From: [sunny.willoughby](#)
To: [Records](#)
Cc: [REDACTED]
Subject: Feedback Submission Re: Revised Future Water Project 2060 – Integrated Water Cycle Management strategy To: General Manager, Rous County Council PO Box 230, Lismore NSW 2480
Date: Sunday, 18 April 2021 7:40:45 AM

Revised Future Water Project 2060 – Integrated Water Cycle Management Strategy (IWCM)

Ballina Environmental Society Submission in Response to Draft revision of the Future Water Project 2060

SUPPLY CURVE - WATER EFFICIENCY OPTIONS

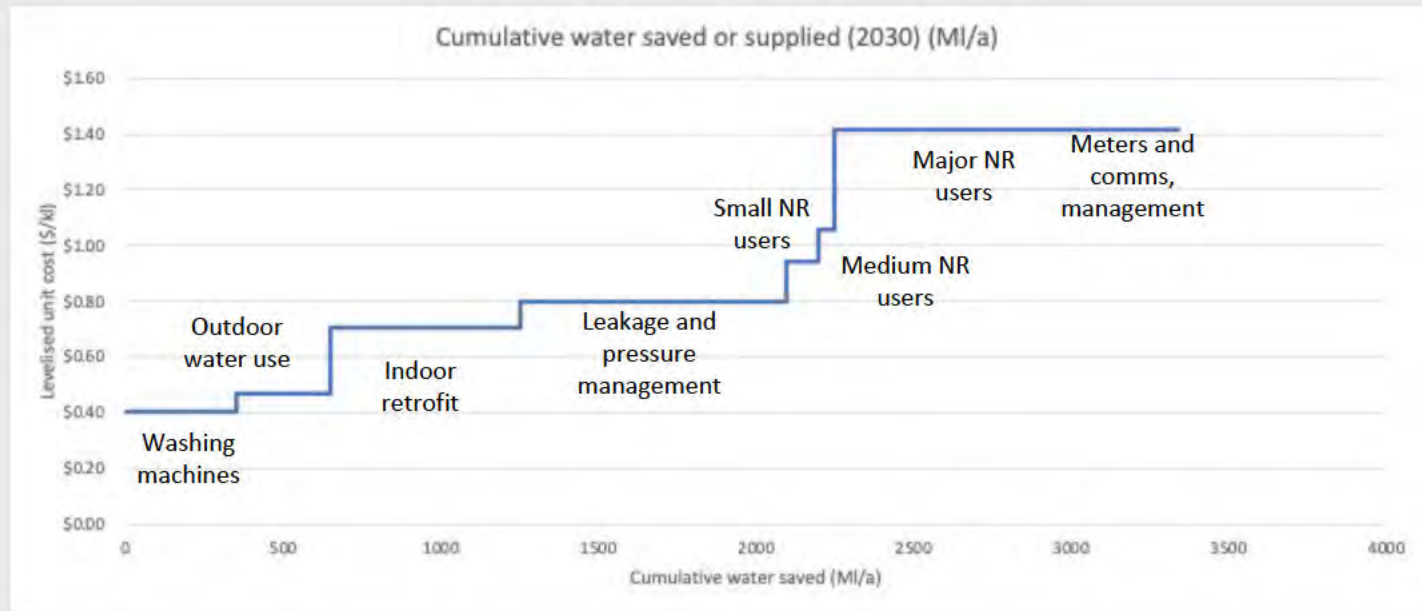
The Dunoon Dam would cost more than four times the cost of this program, and in 2030 would usefully supply about 60% of the volume of water. The unit cost of the water usefully supplied by the Dunoon Dam would be about 9 times the unit cost of the water saved by the water efficiency program.

This graph shows the cumulative contribution to reducing the supply demand gap (as at 2030) on the horizontal or x-axis, and the levelised unit cost of the options on the vertical or y-axis. This is a typical 'supply curve', in this case of conserved water, based on the 'total resource cost' of each option. The levelised cost is calculated by dividing the present value of the stream of capital and operating costs from 2021-2060, by the present value of the volume of water saved (or usefully supplied in the case of Dunoon Dam) over the same period and using the same discount rate. In this case the discount rate is 7% based on NSW Treasury guidelines.

COMPARING WATER EFFICIENCY WITH DUNOON DAM

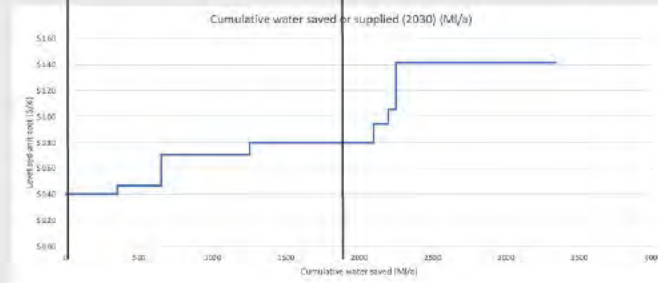
This graph shows the comparison between the unit cost of water usefully supplied by Dunoon Dam (in 2030) compared to the options that form the components of the water efficiency program.

This shows that the unit cost of the water usefully supplied by Dunoon Dam is ~9 times more expensive than the water efficiency program and usefully supplies only 60% of the equivalent demand reduction in 2030 that the water efficiency program would provide.

Yield and demand - different scenarios

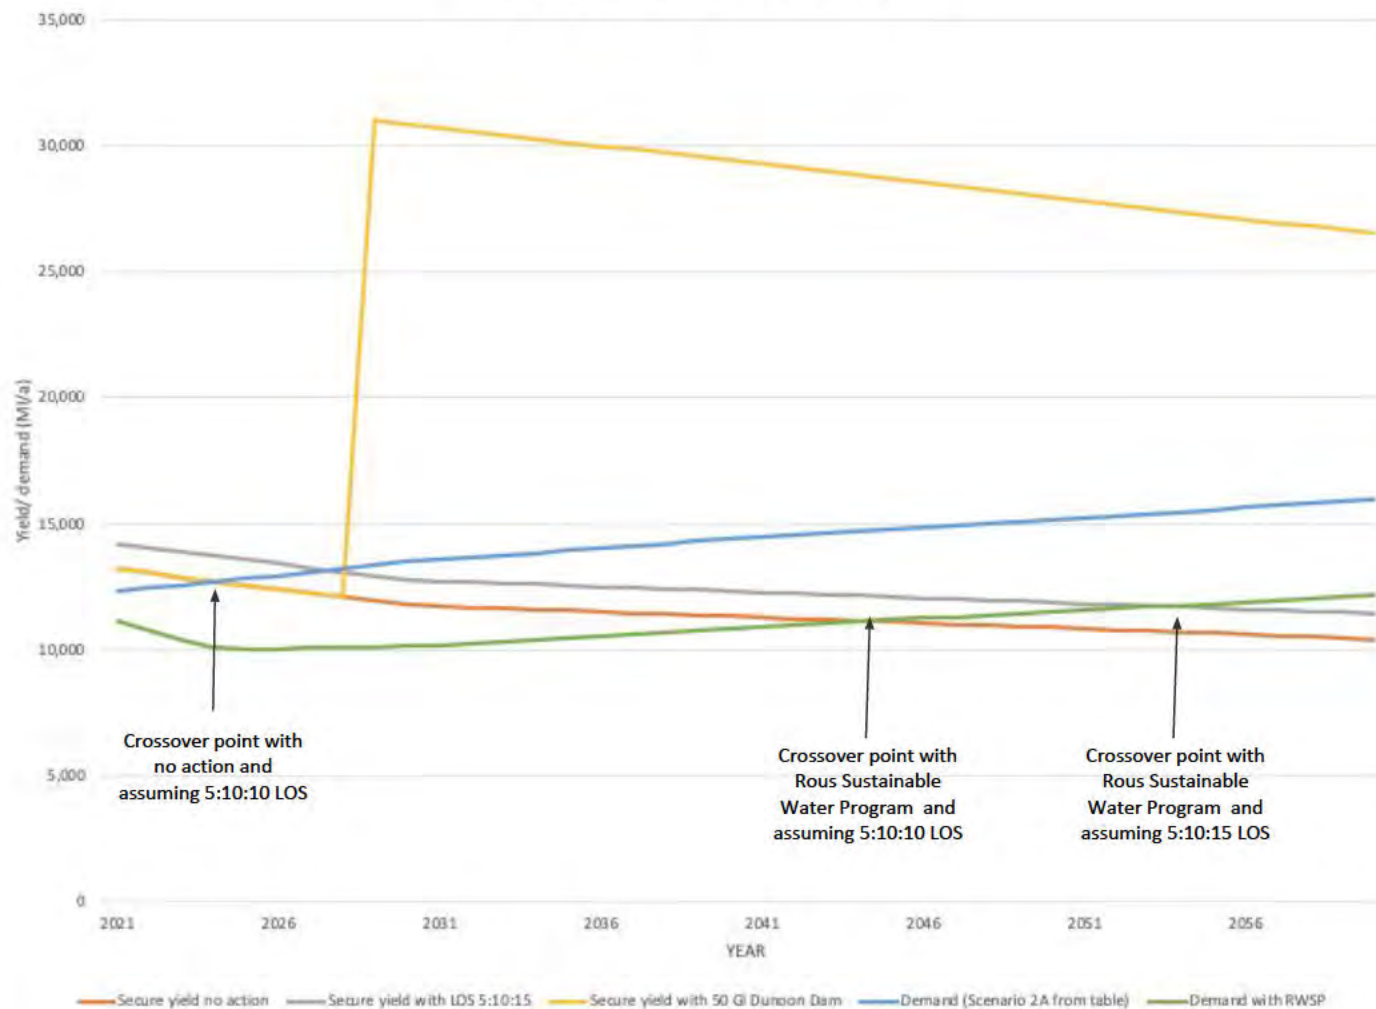
4. The grey line shows the estimated impact of changing the reliability or level of service from the 5:10:10 rule to 5:10:15 ie increasing the yield through allowing restrictions to occur more often and deeper. This would depend on a robust process of community engagement.

5. The impact of the indicative water efficiency program is shown as the green line, and so the point at which the supply-demand balance goes into deficit is pushed out to 2044, or with the change in level of service, out to 2053. This indicates that there is plenty of headroom, that is, even if the assumptions regarding potential efficiency gains were halved, the point of supply-demand deficit could still be pushed out a decade.
